REGULATORY INFORMATION DISTRIBUTION SYSTEM (RIDS)

SUBJECT: Forwards responses to NRC 880121 questions re application to  
 use low enriched U fuel.

Enclosed please find the responses to the questions submitted on January 21, 1988, as a result of our application to use low enriched uranium fuel.

Attachment 2 HEU to LEU Conversion

Figure 10  
VOID COEFFICIENT

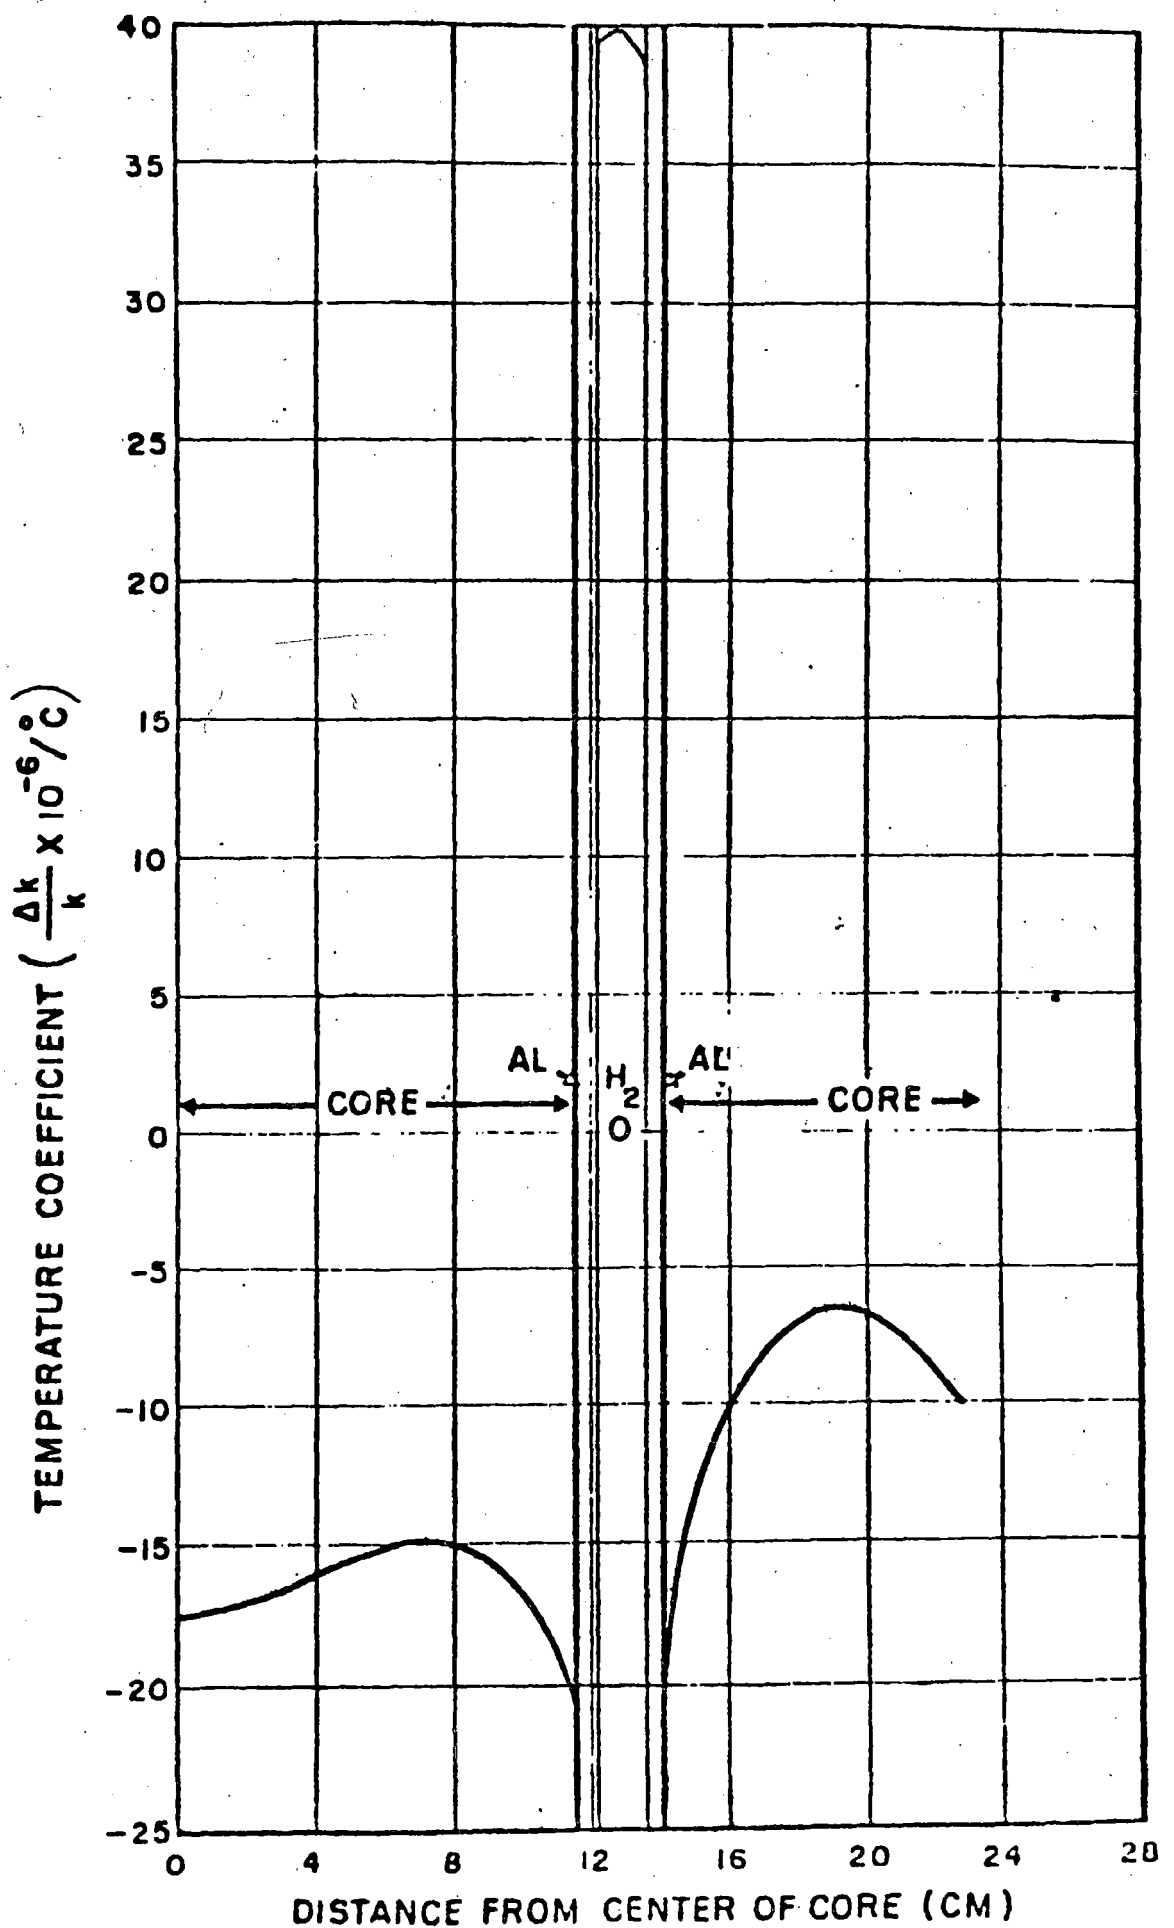
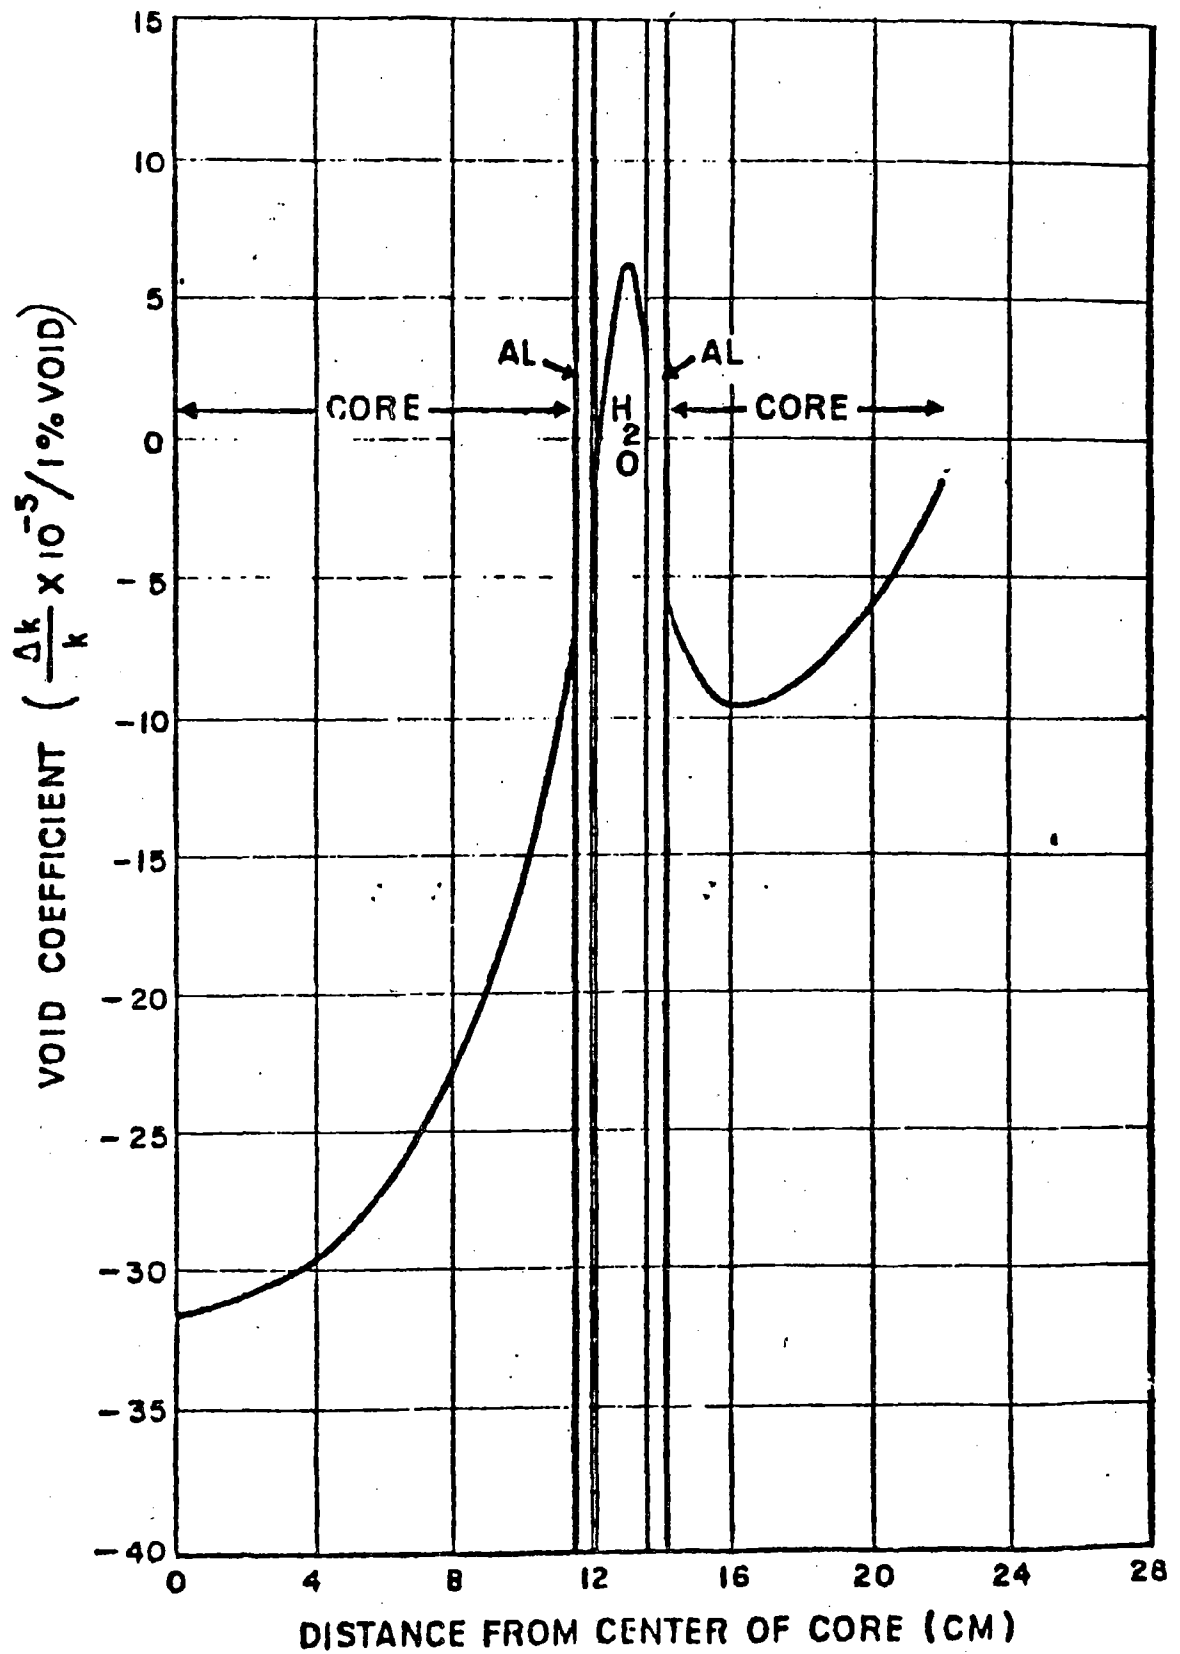
3. In any power excursion, water surrounding the fuel will be heated to a higher temperature (and lower density). Since temperature and void coefficients are more negative in the fuel regions than in the non-fueled regions, such as shown in Figures 9 and 10 from our current SAR, enclosed, any reactivity changes due to temperature and density changes in the fuel regions would be more negative in an excursion than the stated reactivity coefficients would imply, since they are based on an average change throughout the core region, as is discussed in Section 5.7 of the ANL report.
